Subject: [EXTERNAL]File OZS-2021-0018 and OZS-2021-0032

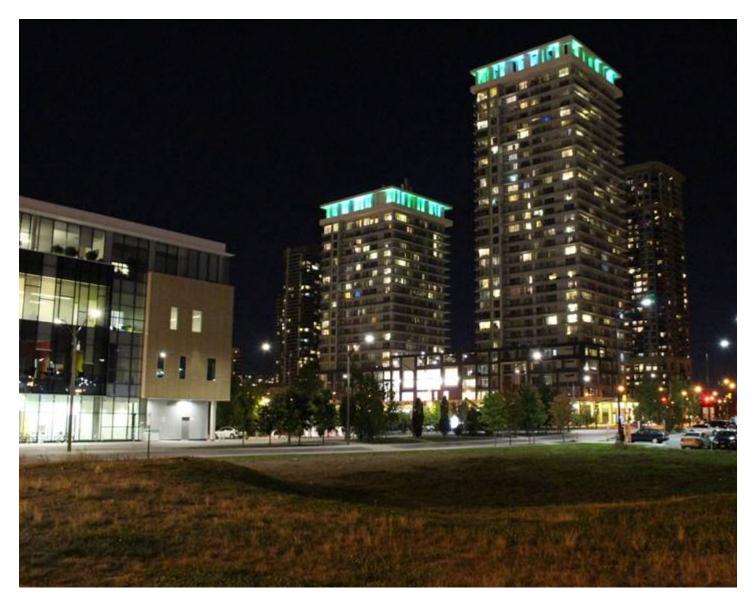
Make the roof a green terraces:

Mechanical Roof penthouse is just a concrete box, should be a more architectural roof design with LED lighting fixture:
